Technical Advisory Group Recommendation

Meeting Date: 09/19/2017

Change Order No. 01

Date of Issuance: 9/28/17 Effective Date: 9/28/17
 Owner: Metro Flood Diversion Authority Owner's Contract No.: WP-28A
 Owner's Representative: CH2M HILL Engineers, Inc. Owner's Representative Project No.: _____
 Contractor: Riley Brothers, Inc. Contractor's Project No.: _____
 Engineer: Houston-Moore Group, LLC Work Package No.: WP-28A
 Project: Fargo-Moorhead Area Diversion Contract Name: Cass County Road 16 & 17 Realignment

FMM Diversion
Proposed County Road 16
Plan & Profile
Sta. 395+00 to Sta. 405+00

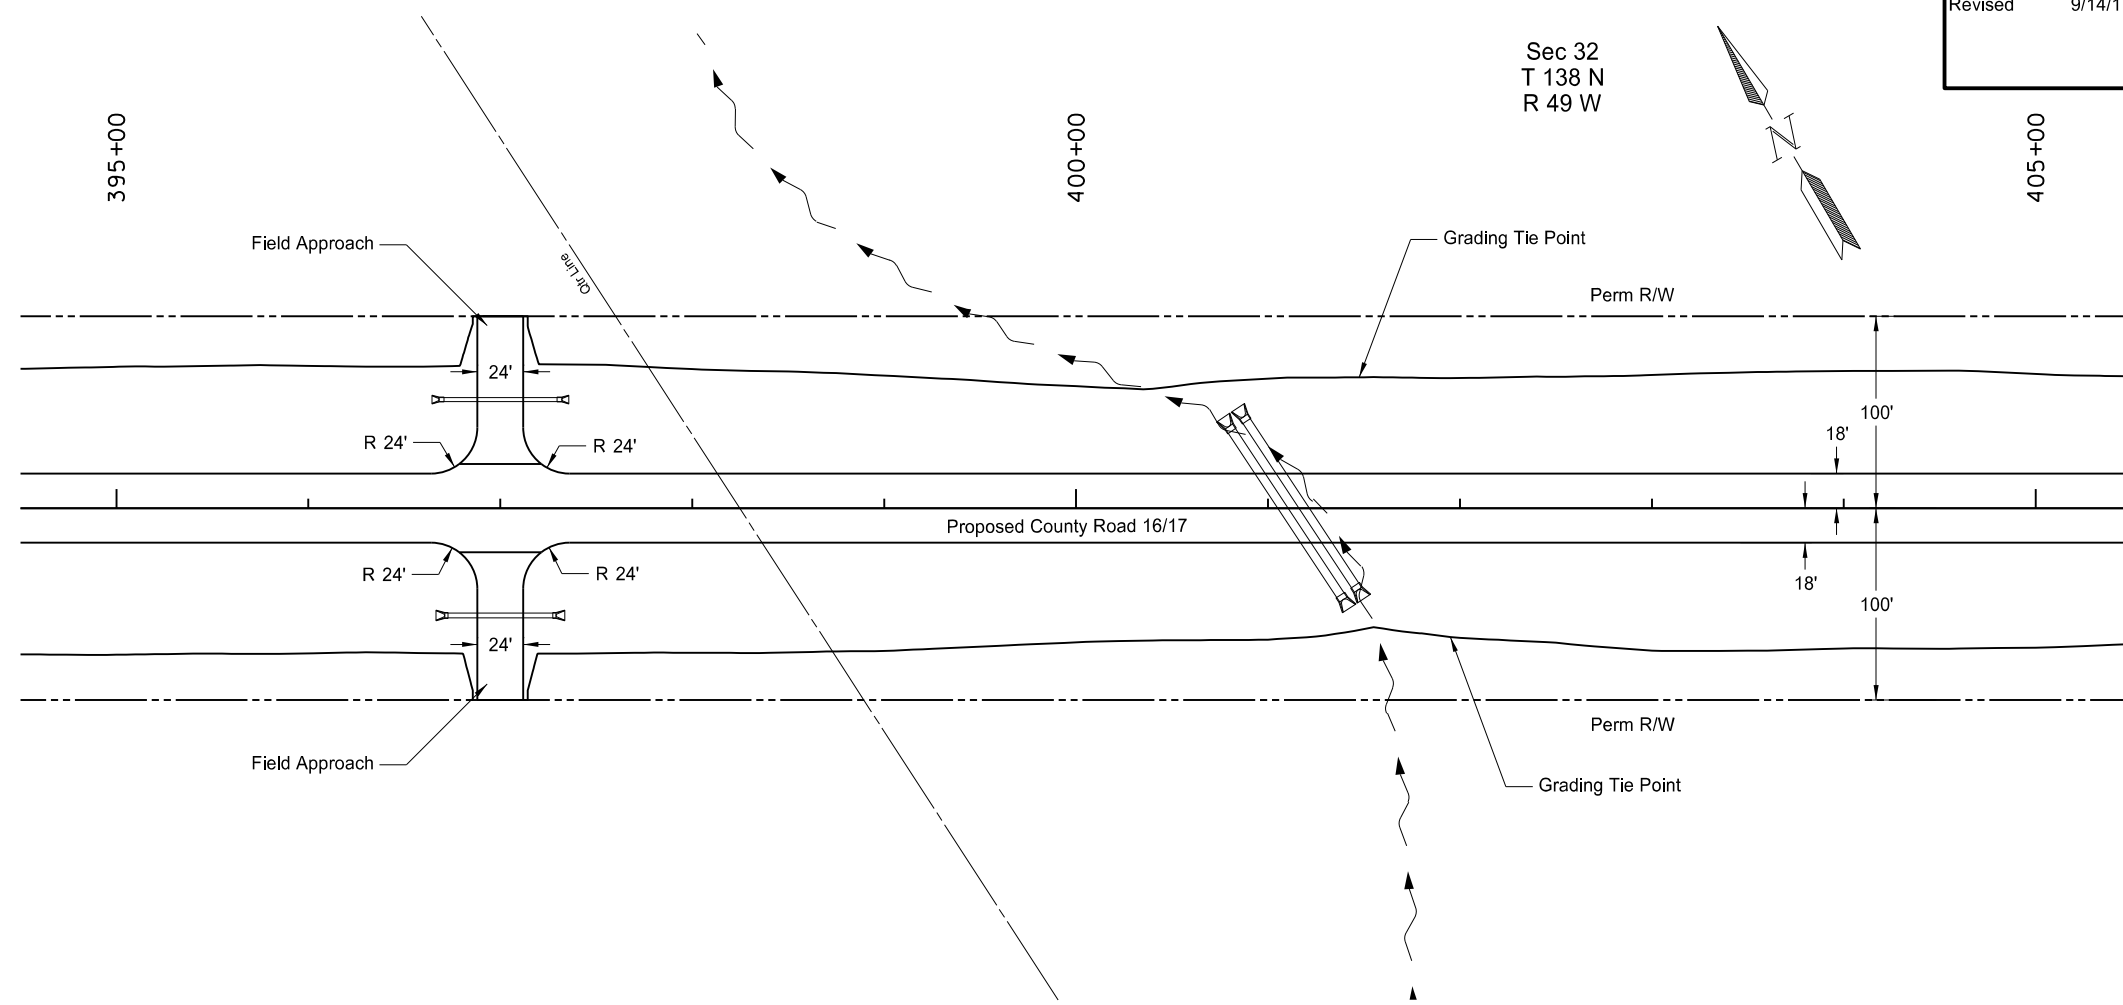
Adjacent landowners have expressed concern over the local drainage prior to the construction of the diversion channel. The drainage plan was reviewed and it meets current NDDOT Stream Water Crossing design standards. However, to match the end area of the upstream drainage structures and ease landowner concern, a second 54" culvert will be installed at Sta 401+19. In addition, the existing culverts north and south of County Road 16, crossing 57th St S will be left in place. These changes will be paid for at the unit prices bid for "202-0174, Removal of Pipe All Types and Sizes" (decrease) and "Pipe Conduit 54IN" (increase). The total cost for drainage modifications is \$21,655.84.

- a. This change item incorporates the cost to add a second 54" culvert.
- b. The schedule change associated with this change item is 0 days.
- c. The PMC has reviewed this change requests and recommends approval.

Adjacent landowners have expressed concern over the local drainage prior to the construction of the diversion channel. The drainage plan was reviewed and it meets current NDDOT Stream Water Crossing design standards. However, to match the end area of the upstream drainage structures and ease landowner concern, a second 54" culvert will be installed at Sta 401+19. In addition, the existing culverts north and south of County Road 16, crossing 57th St S will be left in place. These changes will be paid for at the unit prices bid for "202-0174, Removal of Pipe All Types and Sizes" and "714-4130 Pipe Conduit 54IN". The total cost for the drainage modifications is \$21,655.84. There is no schedule change associated with this change item.

Section 100 Sheet 3

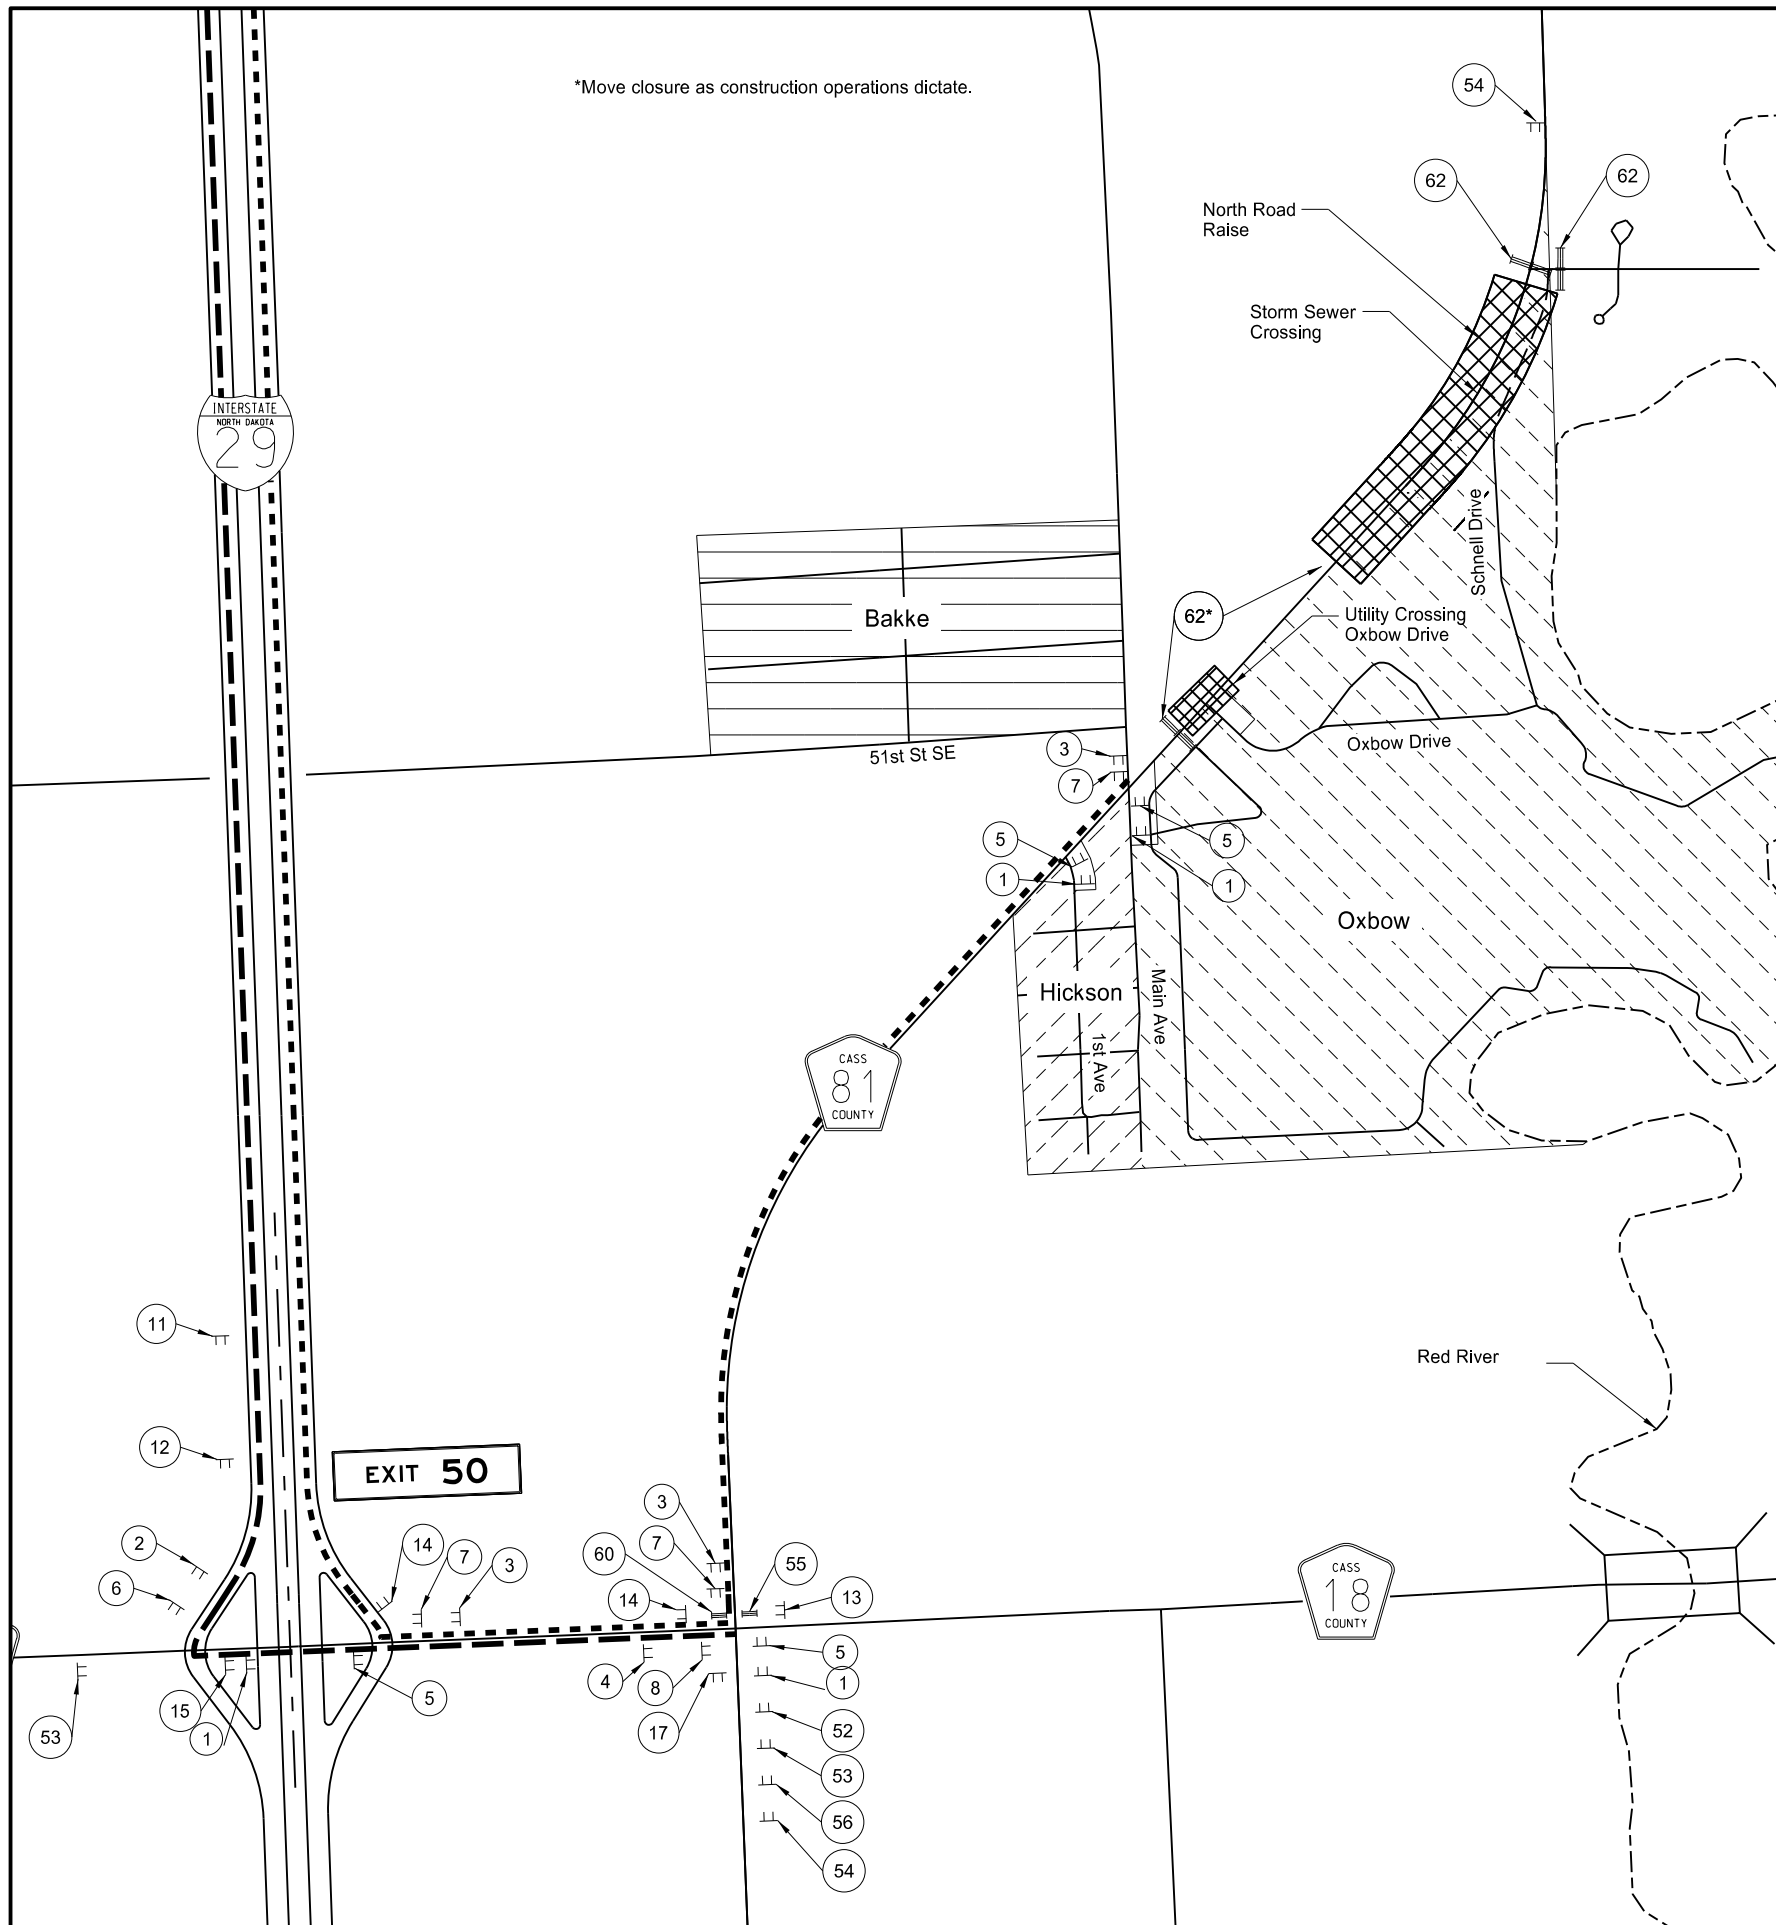
1. Added Type III Barricades and Sign #62 on Paul Bunyan Drive.
2. Added a call showing the Type III Barricades and Sign #62 to be moved from the grade raise to South of Oxbow Drive work limits as contractor operations dictate.

4 SECTION: PIPE BEDDING - STEEL PIPE (DUAL GRAVITY DRAIN)
 CJ403 NOT TO SCALE
 STA 11+50 TO 14+00

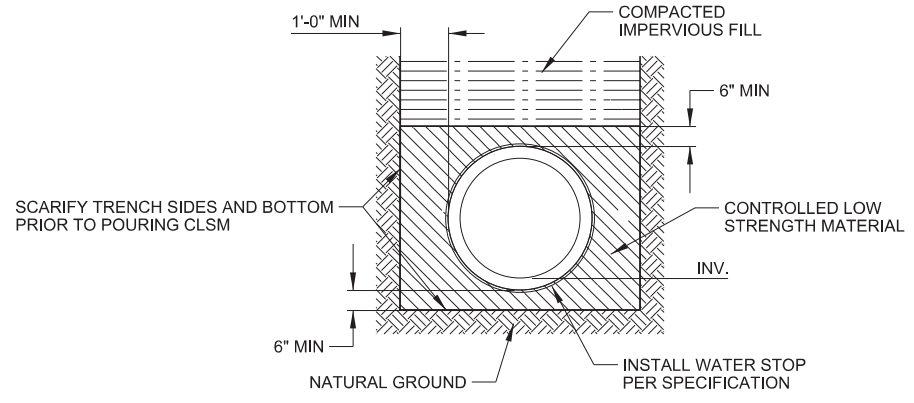
2. Increase 42-inch Steel Pipe Bedding, Backfill, and Time – The Contractor’s bid for 42-inch pipe excavation, bedding, and backfill was based on drawing CJ301/Detail 4, which showed the spacing between the pipes as 4’-0”. Drawing CJ502 shows the spacing between the pipes as 6’-10”. The Engineer of Record clarified in RFI FMDA-RST-000311 that the correct distance between the 42-inch pipes is 6’-10”. The additional 2’-10” width of excavation adds 275 tons of bedding material and 675 cubic yards of excavation and backfill. The time required to excavate and place the additional fill material is one (1) day.
 - a. CH2M and HMG have reviewed this cost and find it acceptable. The total cost for this change item is \$5,328.12.
 - b. CH2M and HMG have reviewed the additional time requested and find it acceptable.

The engineer changed the spacing between the pipe from 4'-0" to 6' 10". As a result of this change it requires the placement of an additional 2' 10" width of bedding in between the 42" steel pipes. Additionally, this change increases the excavation and backfill required for the pipes by 657 cubic yards. The time required to excavate and place the additional fill material is 1 day

The response to RFI FMDA-RSR-000311 modifies the Contract in that on Detail 4 on Sheet CJ301 the spacing is to be changed to 6' 10" between the dual steel pipes. As a result of this change, we will now be required to place an additional 2' 10" width of bedding in between the 42" steel pipes. Additionally, this change also increases the amount of excavation and backfill required for these pipes.

Description/Information Requested: Detail 4 on CJ301 shows 4'0" spacing between dual 42" steel pipe (dual gravity drain).
Details 1&3 on CJ502 show 6'10" spacing between dual 42" steel pipe (dual gravity drain).

Response: Spacing between dual 42" steel pipes is 6'-10"

For Detail 4 on CJ301, the 4'-0" spacing shall be revised to 6'-10"
